Newell Highway Upgrade at Coonabarabran

Submissions report

Transport for NSW | September 2021

FIGURE 3-1: Southern Intersection

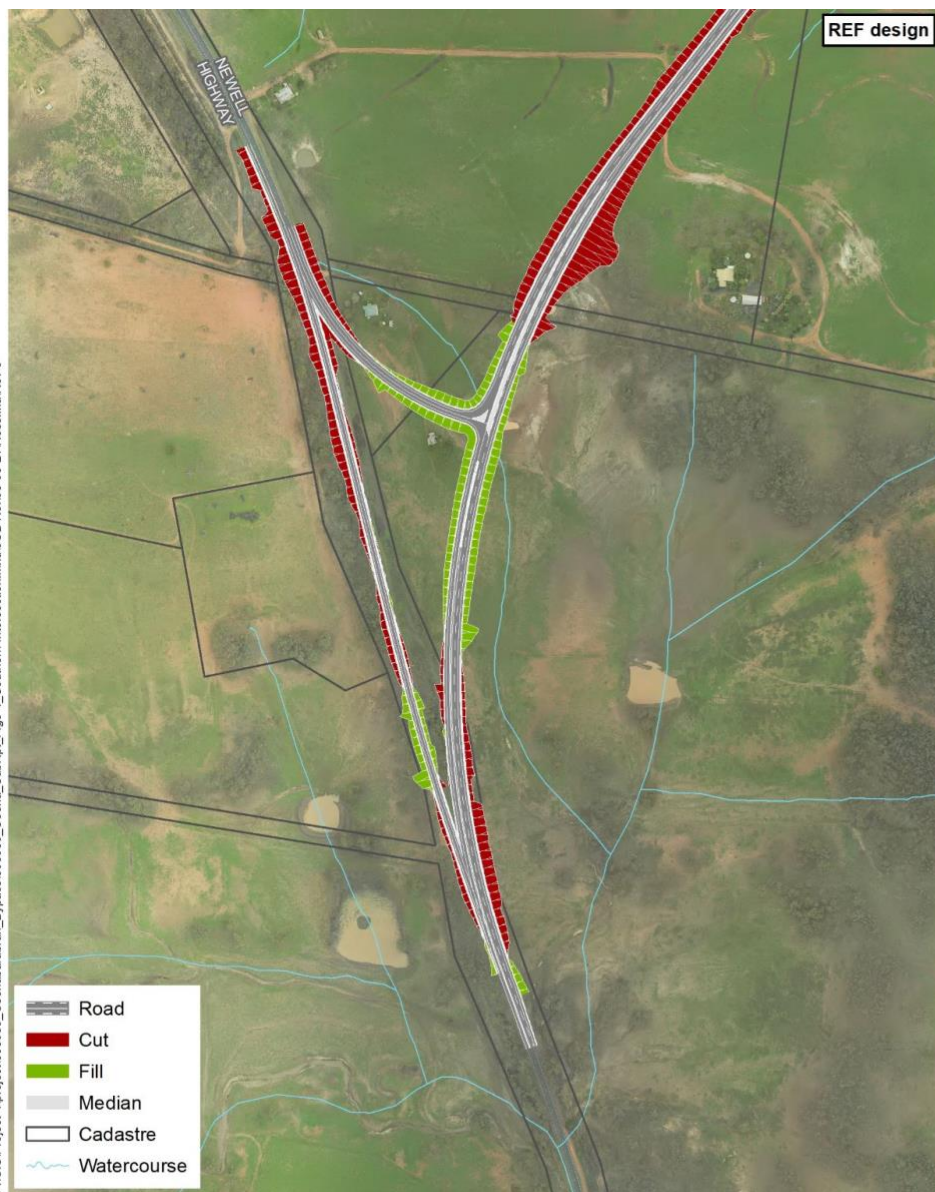
After the REF was issued, a design change was proposed for the southern intersection. The updated southern intersection design provided a new turn-off lane from the highway northbound into Coonabarabran. This would also result in the removal of a section of pavement along the existing highway. The T-intersection was also shifted to the north by around 40 metres. A comparison of the REF design and the updated southern intersection is illustrated in Figure 3.1.

The design change for the southern intersection was proposed to improve driver sight lines for traffic approaching the bypass. The shift in alignment creates a straighter T-intersection with the Newell Highway. This arrangement allows traffic travelling southbound away from Coonabarabran to safely stop at the intersection and provides an improved ability for motorists to judge traffic speed on the highway before they turn onto the highway.

FIGURE 4-1: Vegetation zone

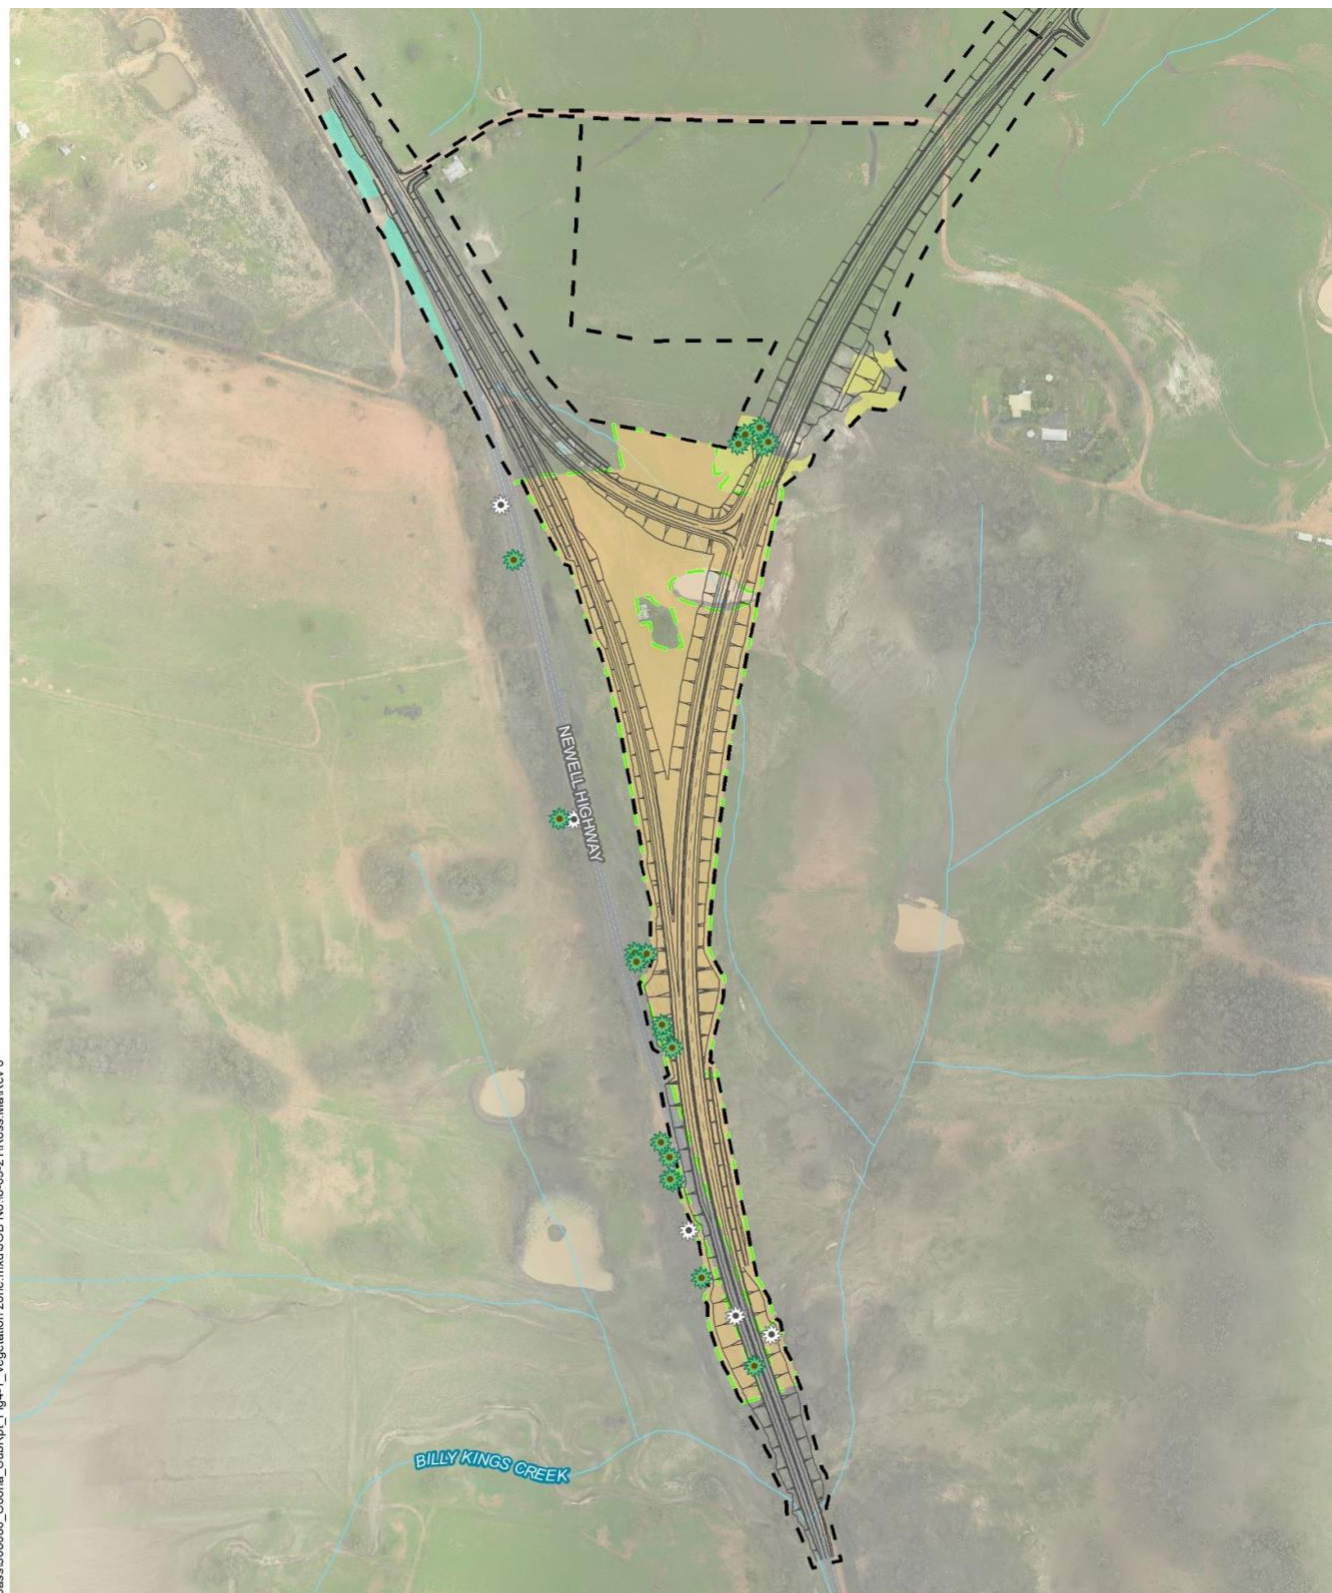
These PCT areas are shown in Figure 4.1. Areas in the figure that do not have an associated PCT are planted non-native grasslands.

The majority of the area of the southern intersection is non-native grasslands. The revised intersection design would remove 11.6 ha (compared to 12.1 ha). The revised design of the southern intersection would result in the reduction in clearing of PCT 434, which is a TEC, no change to the removal of PCT 393 and a slight increase in PCT 417. Actual clearing of PCTs are detailed in Table 4-1.

In addition, the changed design would result in a reduction of Hollow Bearing Trees (HBT) and Stag Trees that fall within the proposal area. The revised design has 10 HBT and 4 stag trees in the proposal area (vegetation clearing line) compared to the REF design, which had 20 HBTs and 7 stag trees. However, it is noted that the trees that no longer fall within the vegetation clearing line are still in close proximity which may require their removal. Where practicable, these habitat trees would not be removed and protected on site through the construction period.
